WYOMING LIBRARY REMODEL

Job No. 6943.03

AS PER ADDENDUM #1

RECORD SET OF DRAWINGS

TITLE: WYOMING LIBRARY REMODEL
ENLARGED PLANS: DOORS TO CHILDRENS' AREA

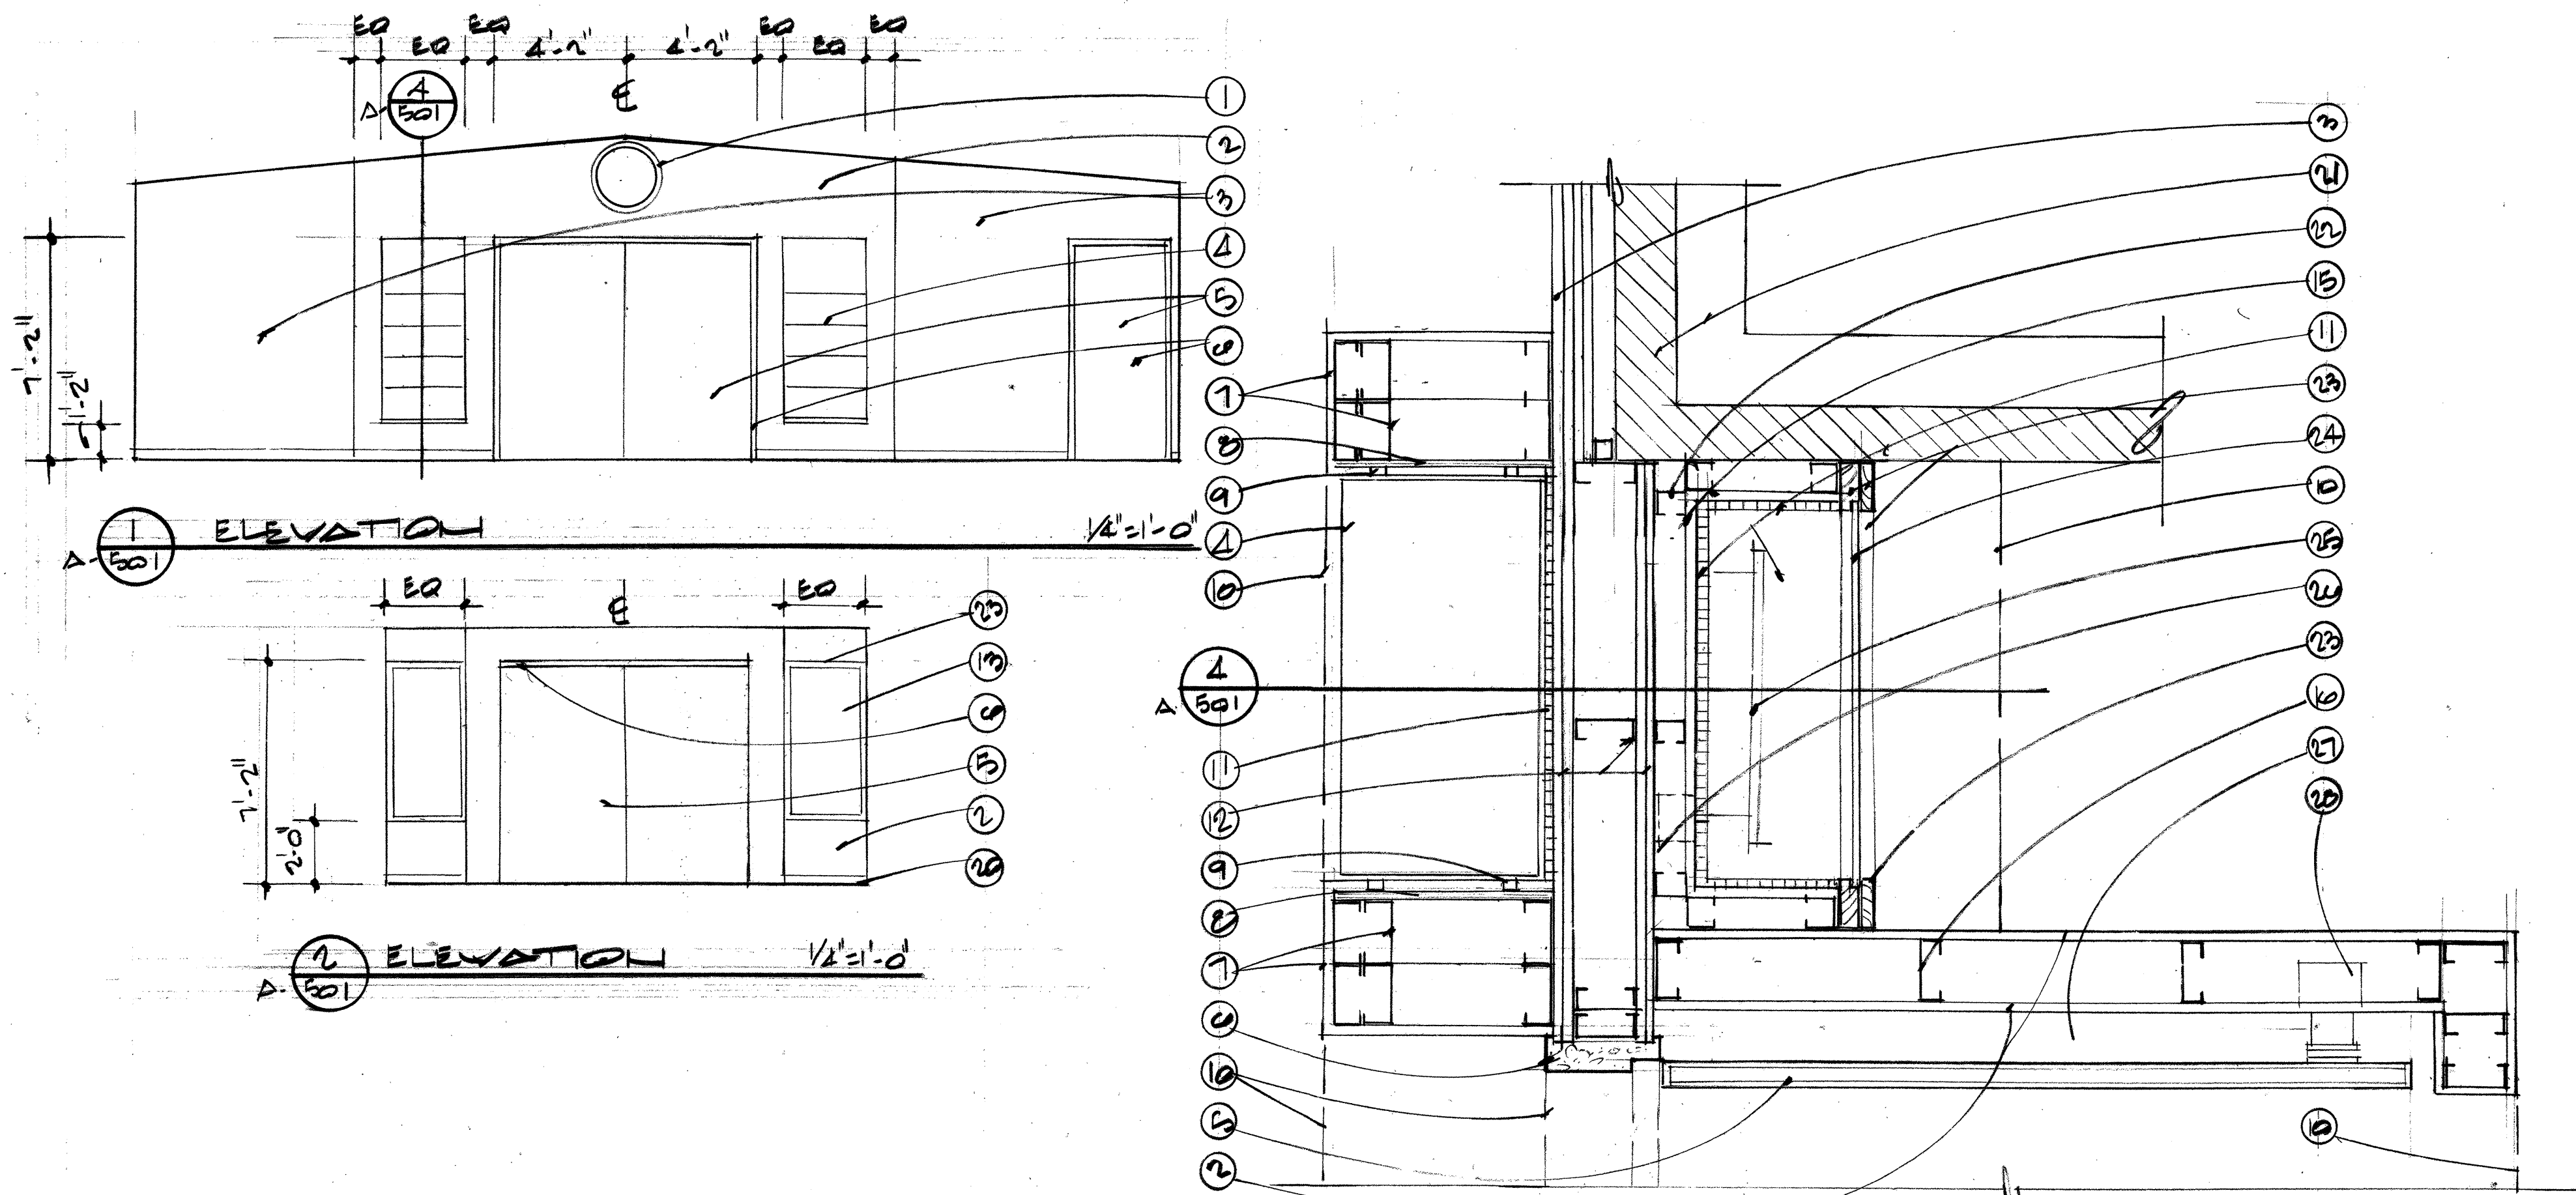
Change at Children's Area Art Glass
 1. Please delete the 1/2" plate mirror at the sides, top and bottom (keyed note #11) of both niches for neon and art glass and paint the gyp. brd. matte black.
 (After experimenting with the neon and art glass we decided to eliminate the mirror and make it a black. The mirror makes it too busy and detracts from the art glass.)
